Technical Memorandum

Subject: Sierra View Shopping Center Site Access Study

RS26-4455

FIGURE 1
Project Site Plan

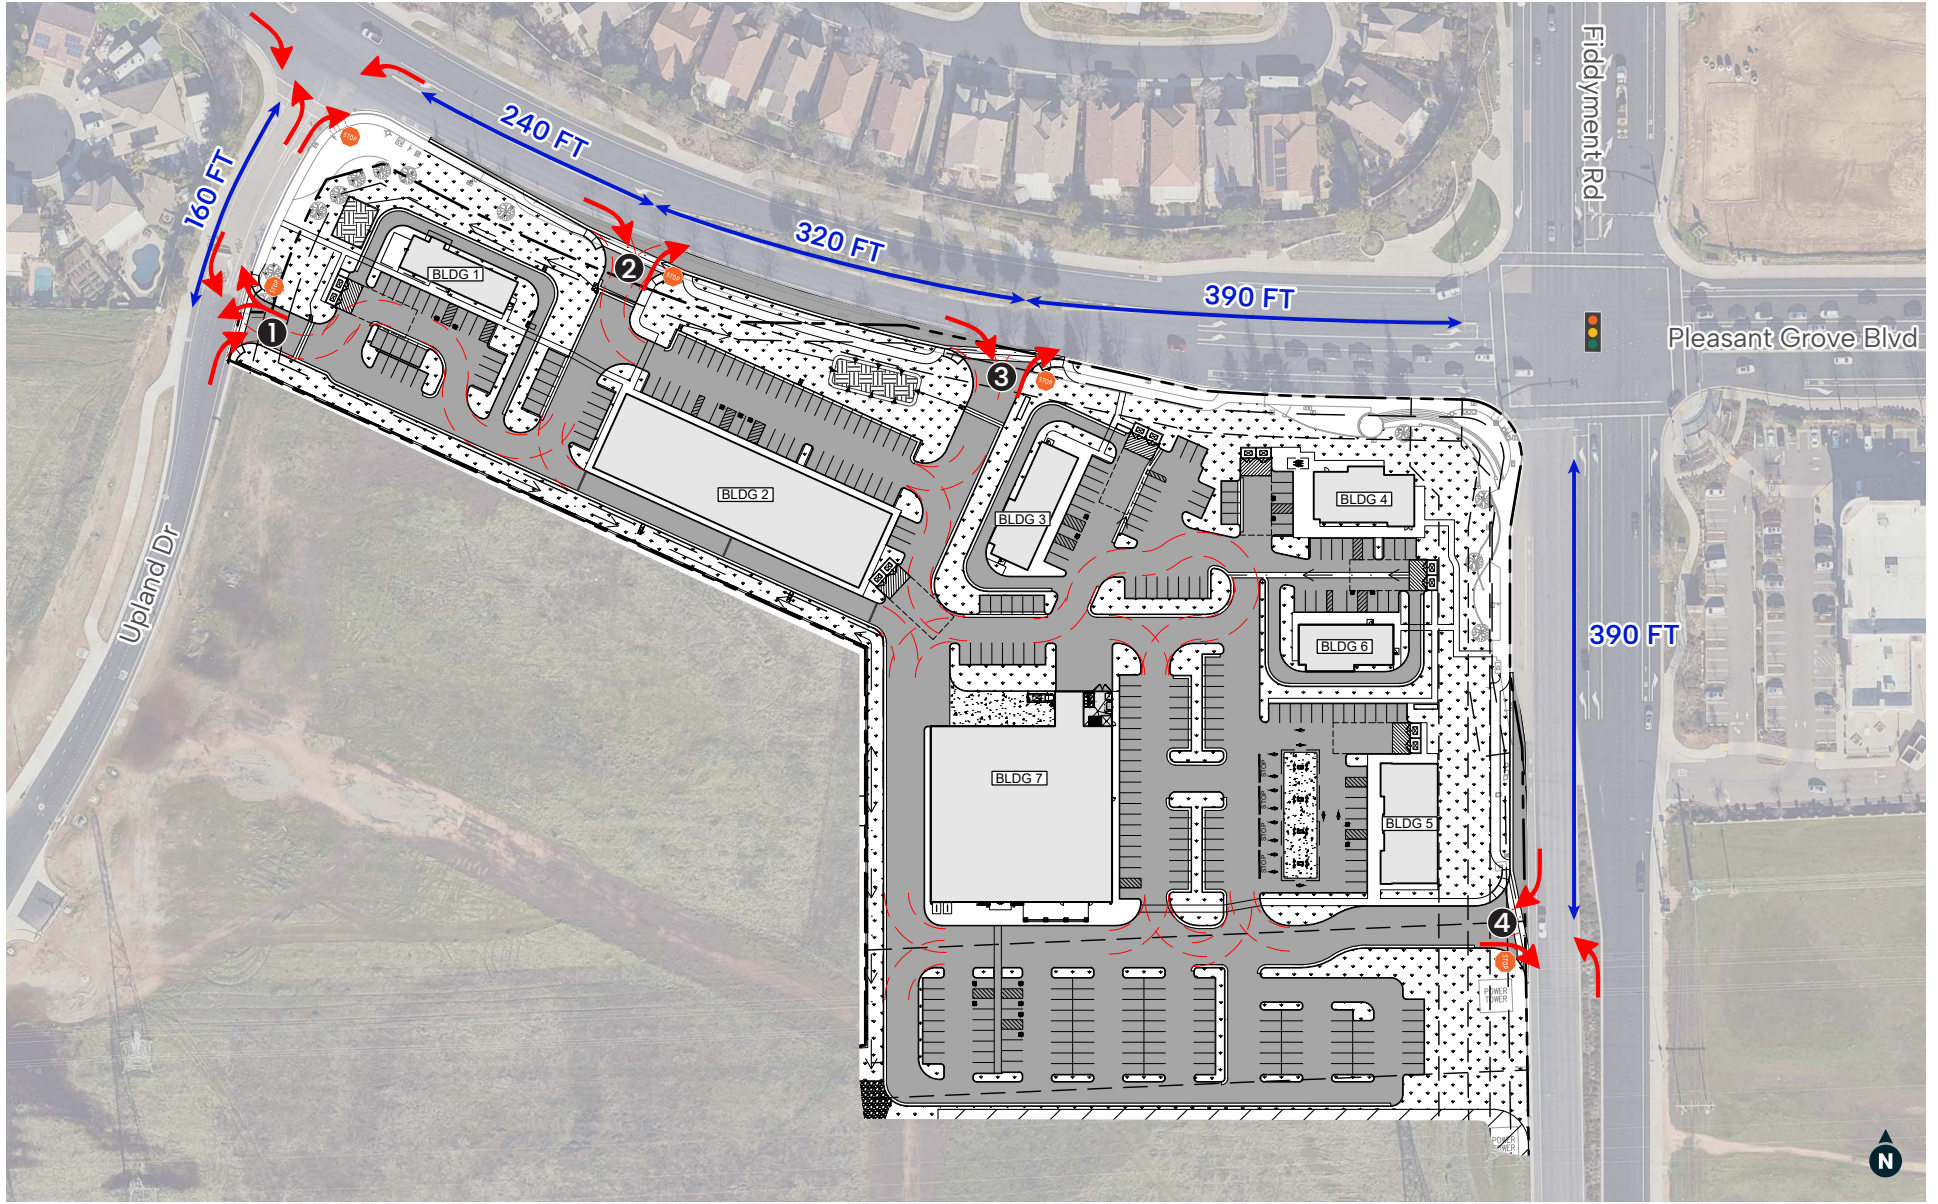
Vehicular access to the project would be provided by four driveways. Each driveway is described below (refer to Figure 1 for driveway spacing):

- Driveway 1 – full access driveway on Upland Drive
- Driveway 2 – westerly right-turn only driveway on Pleasant Grove Boulevard
- Driveway 3 – easterly right-turn only driveway on Pleasant Grove Boulevard
- Driveway 4 – right in/out and left-turn ingress driveway on Fiddymment Road

- c. The driveway is at least 400 feet downstream and 600 feet upstream of an intersection containing left turn pockets. **Does not comply as 390-foot driveway spacing is 10 feet short of this standard.** ² Further evaluation of this standard is included at the end of this section.

² According to the site plan, Driveway 4 would be situated 27 feet from a Western Area Power Authority (WAPA) electrical transmission tower. According to *Living and Working Around High Voltage Power Lines* (WAPA, 2021), 15 feet is a commonly referenced minimum distance from the tower to streets, driveways, parking lots, walkways, etc. Notably, a WAPA tower is situated 7 feet from the face of curb on Shasta Street in Roseville.

With regard to standard 5c listed above, it would appear that Driveway 4 could be relocated 10 feet to the south. Doing so would enable compliance with this standard and further enhance sight distance (though marginally) for the northbound left-turn ingress movement. We do not have any background information with respect to why the driveway is spaced at its current location. **We recommend that the City and applicant discuss where the driveway should be located and revise the site plan if needed.**

- Drive Aisle Behind Building 2 – This two-way drive aisle provides direct access to/from Driveway 1 on Upland Drive to the central part of the site. As this drive aisle is straight without any traffic controls, speeding could occur. The updated site plan now shows three lines the drive aisle behind this building, which presumably represents speed bumps or similar speed management devices that were previously recommended.

- Access to Fuel Pumps from Driveway 4 – Motorists entering the site from Driveway 4 and wanting to access the fuel pumps (which allow for westbound one-way only travel) would need to perform a reverse u-turn at the first internal intersection and then use the eastbound-only drive aisle to access the pumps (refer to Figure 3 for path of travel). This movement would likely be challenging for trucks and large SUVs due to the lack of any curb return radius at the curve and a receiving lane that is less than 15 feet wide (when a vehicle is fueling up at the adjacent pump).

Recommendation 7: Redesign the southerly part of the convenience market / fueling pumps site layout to better accommodate traffic entering from Driveway 4.

FIGURE 2

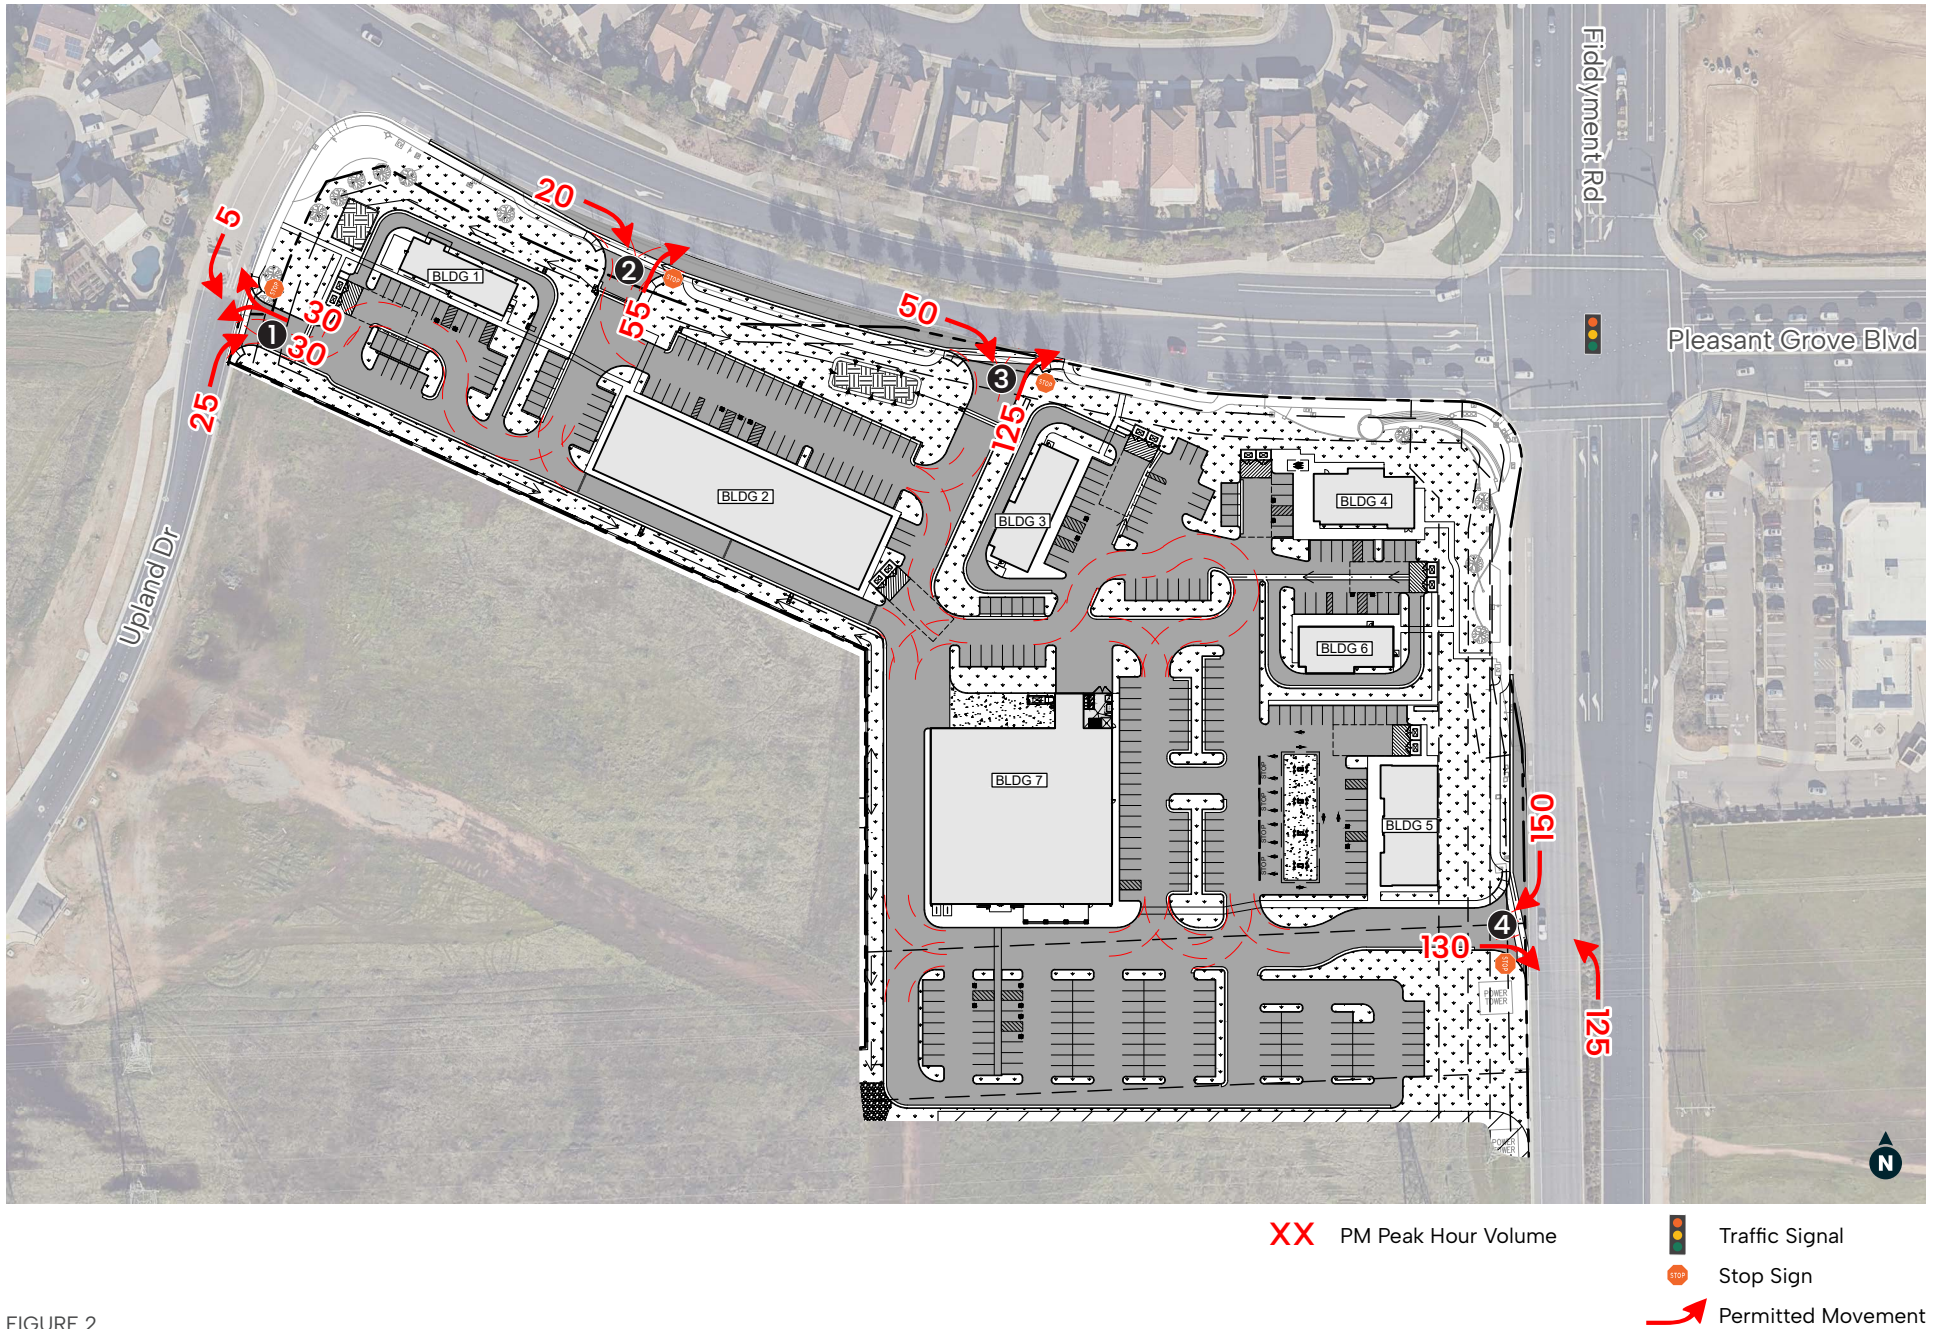
We developed weekday PM peak hour forecasts at the driveways based on the project's trip generation and distribution, permitted driveway turning movements, and on-site circulation layout. **Figure 2** display the expected weekday PM peak hour driveway volumes.

FIGURE 3

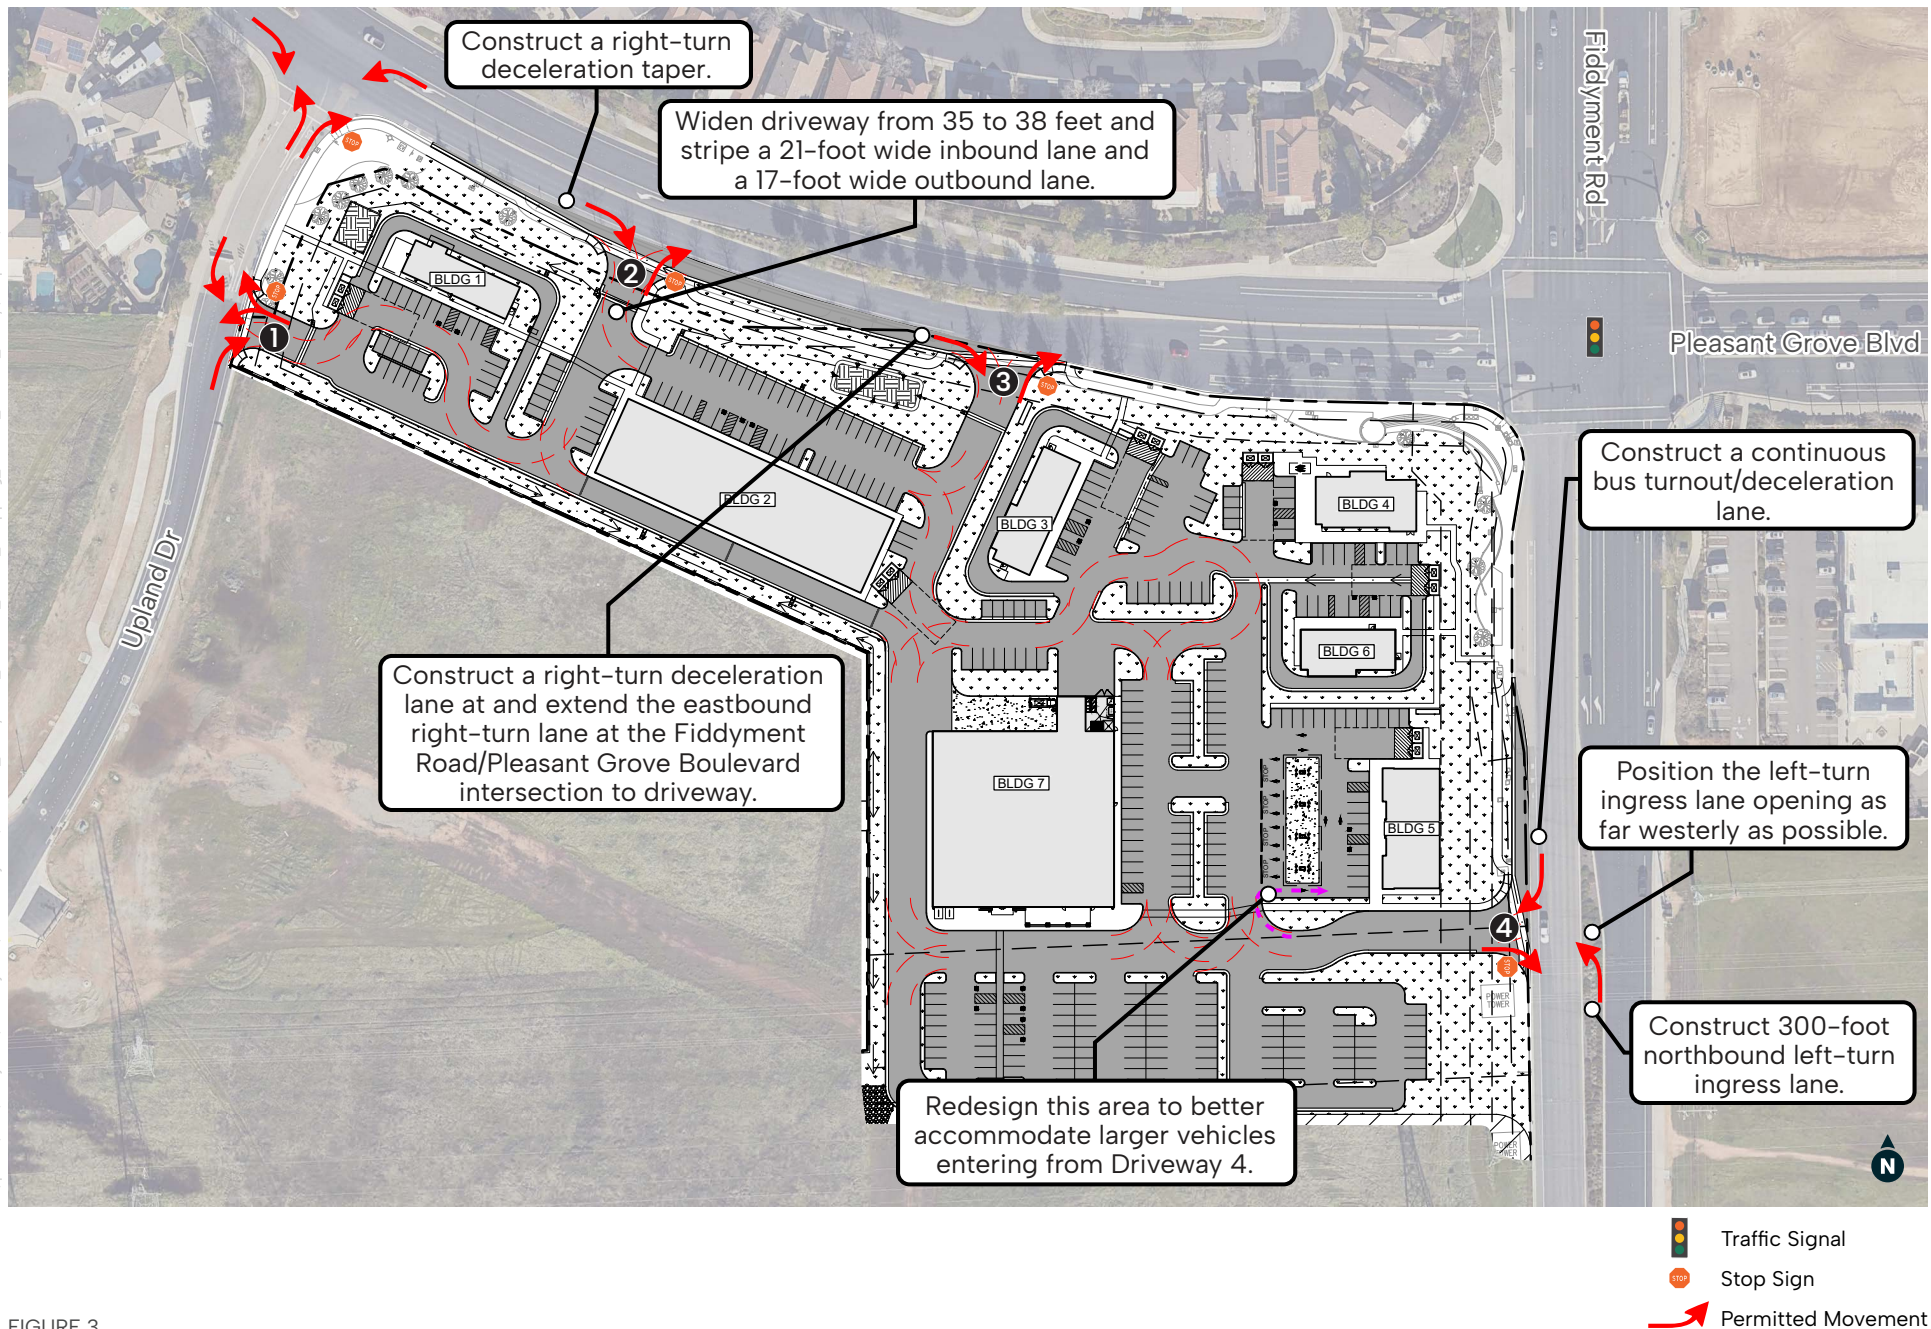
Recommendation 1: Construct a continuous bus turnout/deceleration lane on Fiddymment Road at Driveway 4.

Recommendation 2: Construct 300-foot northbound left-turn ingress lane at Driveway 4.

Recommendation 3: Construct a right-turn deceleration taper at Driveway 2.

Recommendation 4: Construct a right-turn deceleration lane at Driveway 3 and extend the eastbound right-turn lane at the Fiddymment Road/Pleasant Grove Boulevard intersection to Driveway 3, creating a continuous acceleration/deceleration lane.

Recommendation 5: Widen Driveway 2 from 35 to 38 feet and stripe a 21-foot wide inbound lane and a 17-foot wide outbound lane.

Recommendation 6: Position the left-turn ingress lane opening at Driveway 4 as far westerly as possible to maximize visibility of oncoming traffic.

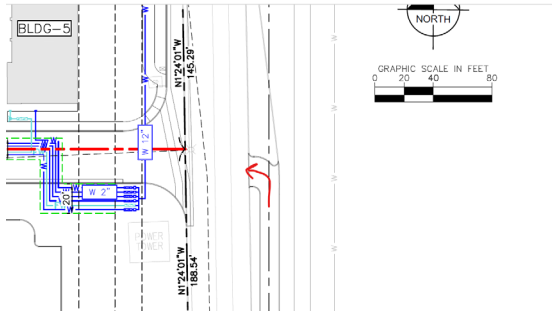
Appendix A shows a motorist’s approximate line of sight from the opening of the left-turn ingress lane at Driveway 4 and looking north. As shown, a southbound vehicle departing the Pleasant Grove Boulevard/Fiddymment Road intersection would be visible to a motorist in the left-turn lane for a distance of about 435 feet. As shown, vehicles queued in the northbound left-turn lane at the Fiddymment Road/Pleasant Grove Boulevard intersection do not block this line of sight.

Turn lane location relative to existing street light positioned in the center of driveway location.
Note the 435-foot distance below is greater than the 390 ft spacing on Figure 1. The 45-foot difference is due to the added distance between the curb return and the crosswalk as well as location of vehicle waiting at Dwy 4
